SUBJECT: CALVERT CLIFFS NUCLEAR POWER PLANT, UNITS 1 AND 2 - STAFF ASSESSMENT OF INFORMATION PROVIDED PURSUANT TO TITLE 10 OF THE *CODE OF FEDERAL REGULATIONS* PART 50, SECTION 50.54(f), SEISMIC HAZARD REEVALUATIONS FOR RECOMMENDATION 2.1 OF THE NEAR-TERM TASK FORCE REVIEW OF INSIGHTS FROM THE FUKUSHIMA DAI-ICHI ACCIDENT (TAC NOS. MF3970 AND MF3971)

STAFF ASSESSMENT BY THE OFFICE OF NUCLEAR REACTOR REGULATION

RELATED TO SEISMIC HAZARD AND SCREENING REPORT

CALVERT CLIFFS NUCLEAR POWER PLANT, UNITS 1 AND 2

Figure 3.3-1 Plot of NRC Staff and Licensee's Base Case Shear-Wave Velocity Profiles for the Calvert Cliffs site

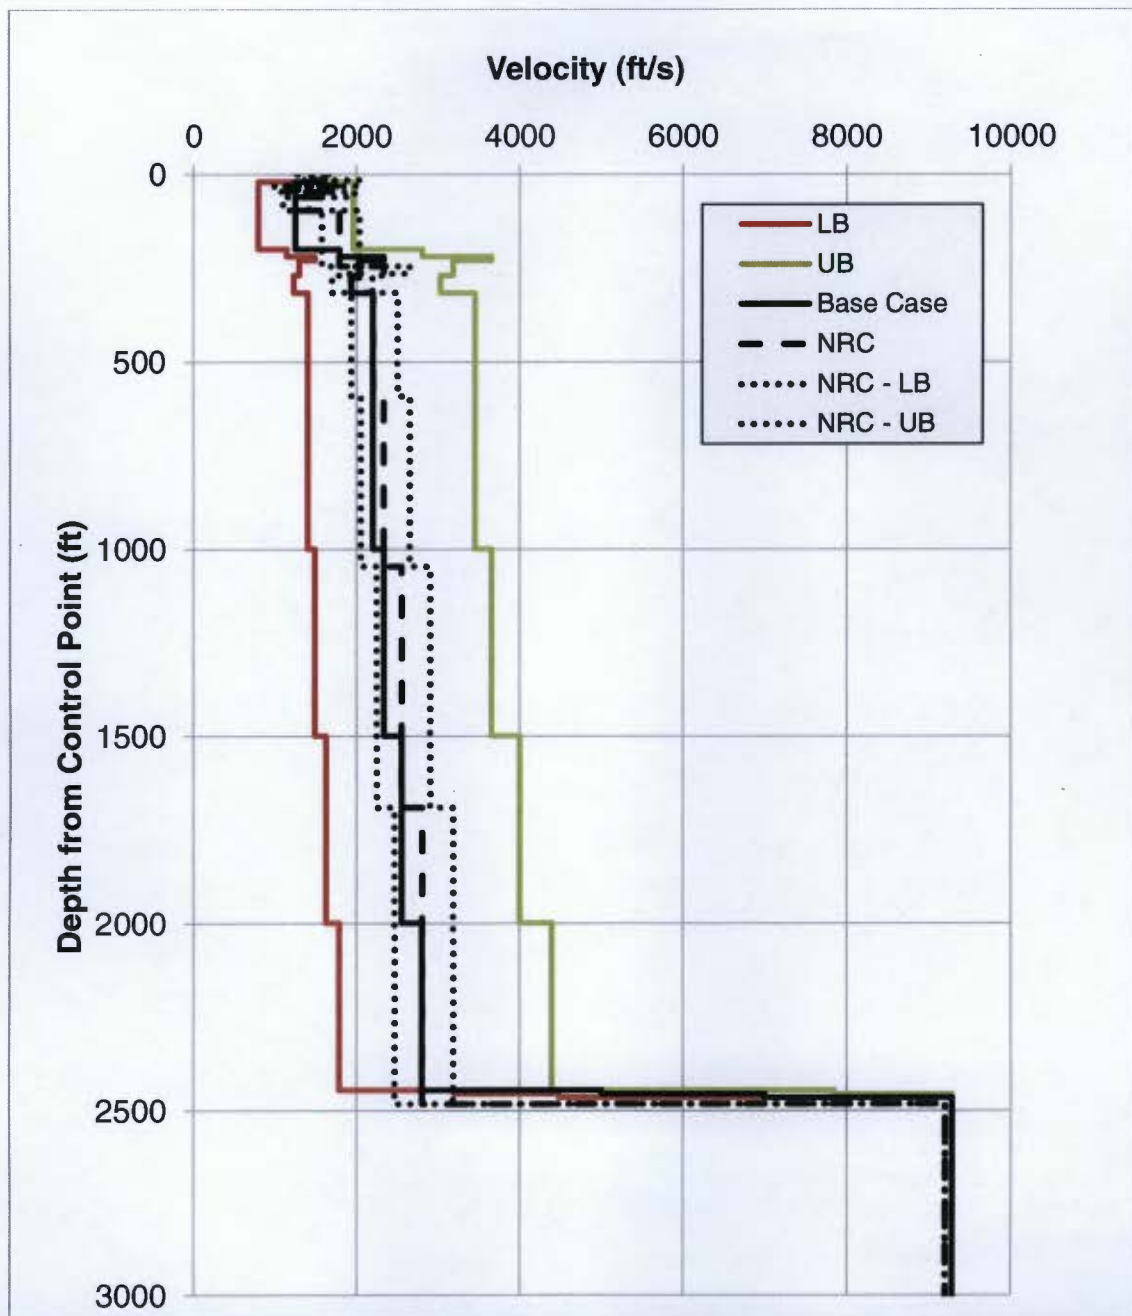
To confirm the licensee's site response analysis, the staff performed site response calculations for the CCNPP site. The staff independently developed a shear-wave velocity profile, damping values, and modeled the potential nonlinear behavior of the rocks. For its site response calculations, the staff employed the RVT approach and developed input ground motions in accordance with Appendix B of the SPID. The staff's shear wave velocity profile was primarily adapted from the Calvert Cliffs, Unit 3 Combined Operating License (COL) FSAR. The operating plant is close to the COL site; the distance is on the order of several hundred meters. However, because it is likely that the shear wave velocities differ somewhat between the COL site and the operating plant site, the staff developed upper and lower velocity models in addition to the median case using a natural log sigma of 0.1. To capture the uncertainty in the depth to base rock beneath the site, the staff also used a natural log sigma of 0.1, resulting in a basement uncertainty of about  $\pm 250$  feet. Figure 3.3-1 of this assessment shows the staff's velocity profile compared to the three base-case profiles developed by the licensee. The staff's control point is on top of the Chesapeake group, which is the same location as the licensee's control point.

Overall, the staff's velocity profiles are similar to those developed by the licensee. Similar to the licensee, the staff also used the SPID guidance in developing the appropriate dynamic properties by using the appropriate EPRI soil and Peninsular curves. The staff's model, however, assumed a linear response below a depth of 360 ft [110 meters] whereas the licensee assume a linear response below a depth of 500 ft [152 meters]. For the site kappa values, the staff also estimated a value above 0.04 s and therefore, used a kappa value 0.04 s to be consistent with the SPID guidance.

**Figure 3.3-2 Plot Comparison of the NRC Staff and the Licensee's Median Amplification Functions and Uncertainties for the Calvert Cliffs site**

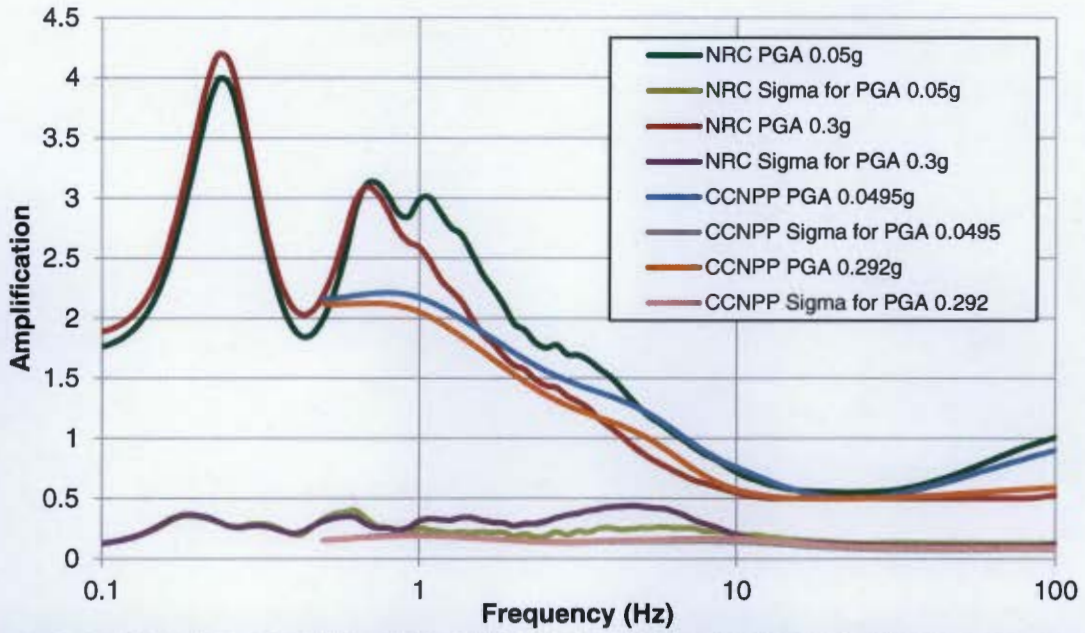
Figure 3.3-2 of this assessment shows a comparison of the staff's and licensee's median site amplification functions and uncertainties ( $\pm 1$  standard deviation) for two of the eleven input loading levels. Even though there are some variations in site amplifications due to differing input model parameters, as shown in Figure 3.3-3 of this assessment, these differences do not impact the final control point hazard curves. Appendix B of the SPID provides guidance for performing site response analyses, including capturing the uncertainty for sites with less subsurface data; however, the guidance is neither entirely prescriptive nor comprehensive. As such, various approaches in performing site response analyses, including the modeling of uncertainty, are acceptable for this application.

Figure 3.3-3 Plot Comparison of the NRC staff and the Licensee's Mean Control Point Hazard Curves at a Variety of Frequencies for the Calvert Cliffs site

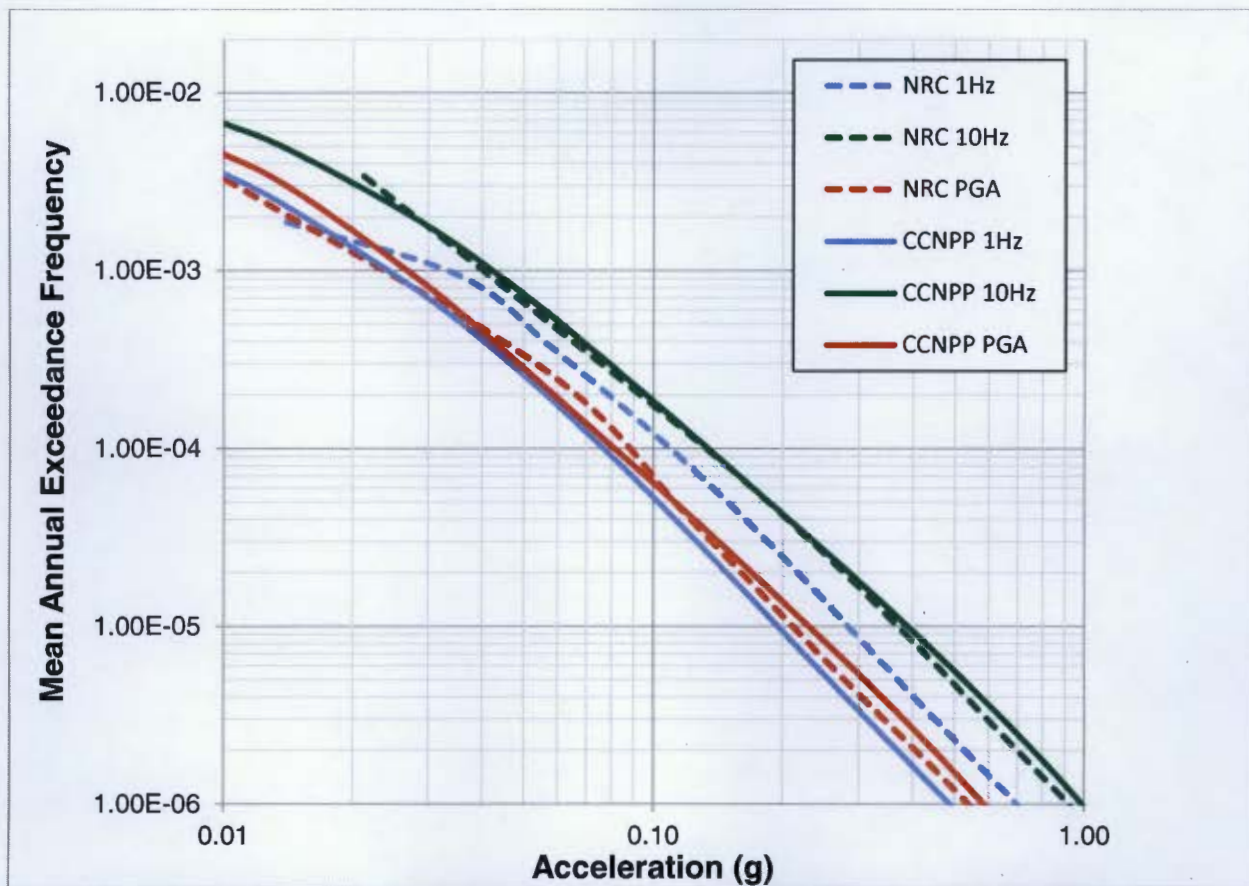
In summary, the staff concludes that the licensee's site response was conducted using present-day guidance and methodology, including the NRC-endorsed SPID. The staff performed independent calculations which confirm that the licensee's amplification factors and control point hazard curves adequately characterize the site response, including the uncertainty associated with the subsurface material properties, for the CCNPP site.

Figure 3.4-1 Comparison of the NRC staff GMRS with Licensee's GMRS and the Unit Nos. 1 and 2 SSE for the Calvert Cliffs site

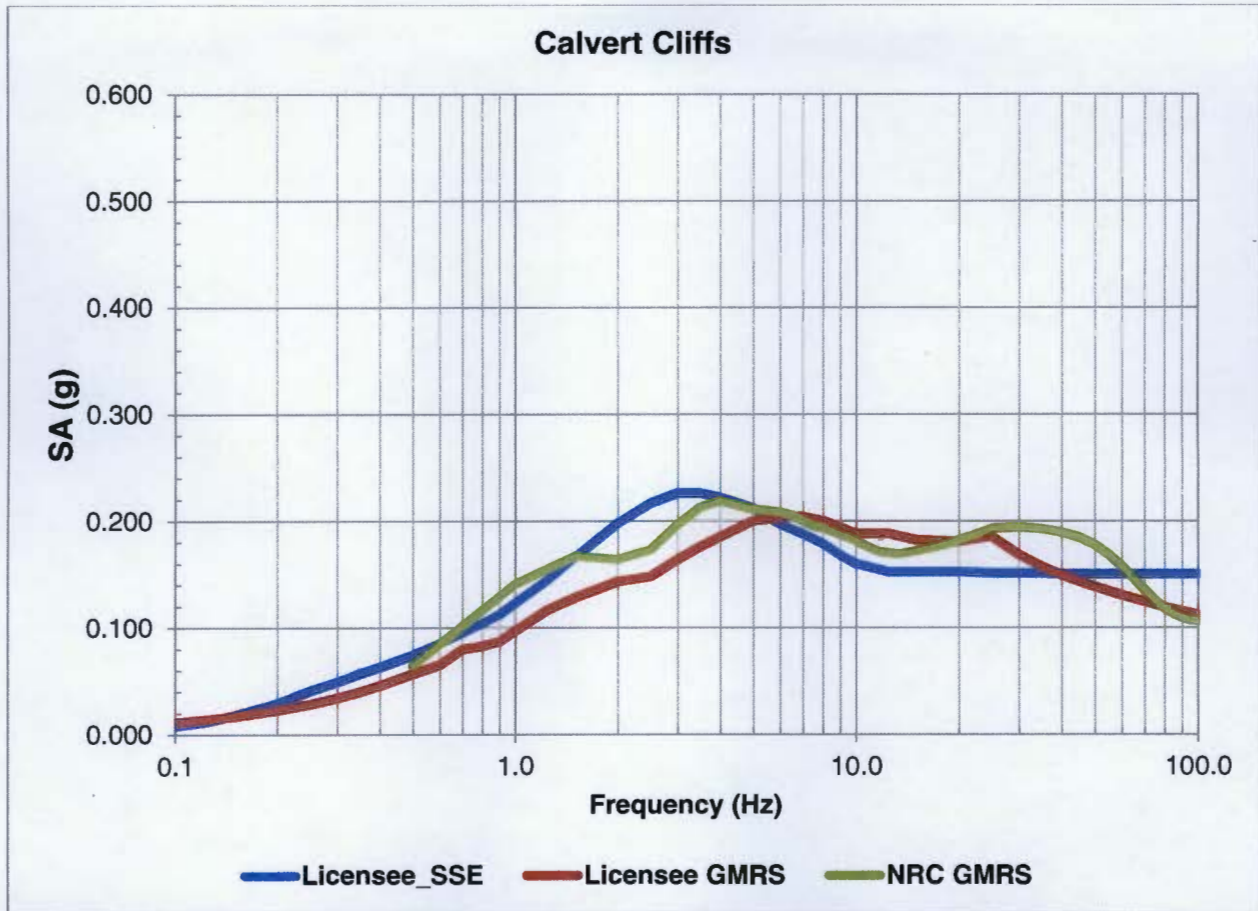
The staff independently calculated the  $10^{-4}$  and  $10^{-5}$  UHRS using the results of its confirmatory PSHA and site response analyses, as described in Sections 3.2 and 3.3 of this staff assessment, respectively. Figure 3.4-1 of this assessment shows a comparison of the GMRS determined by the licensee to that determined by the staff. As shown in Figure 3.4-1, the NRC's GMRS shape is generally similar to the licensee's GMRS across the entire frequency range.

The staff confirms that the licensee used the present-day guidance and methodology outlined in RG 1.208 and the SPID to calculate the horizontal GMRS, as requested in the 50.54(f) letter. The staff performed both a PSHA and site response confirmatory analysis and achieved results consistent with the licensee's horizontal GMRS. As such, the staff concludes that the GMRS determined by the licensee adequately characterizes the reevaluated hazard for the CCNPP site. Therefore, this GMRS is suitable for use in subsequent evaluations and confirmations, as needed, for the response to the 50.54(f) letter.
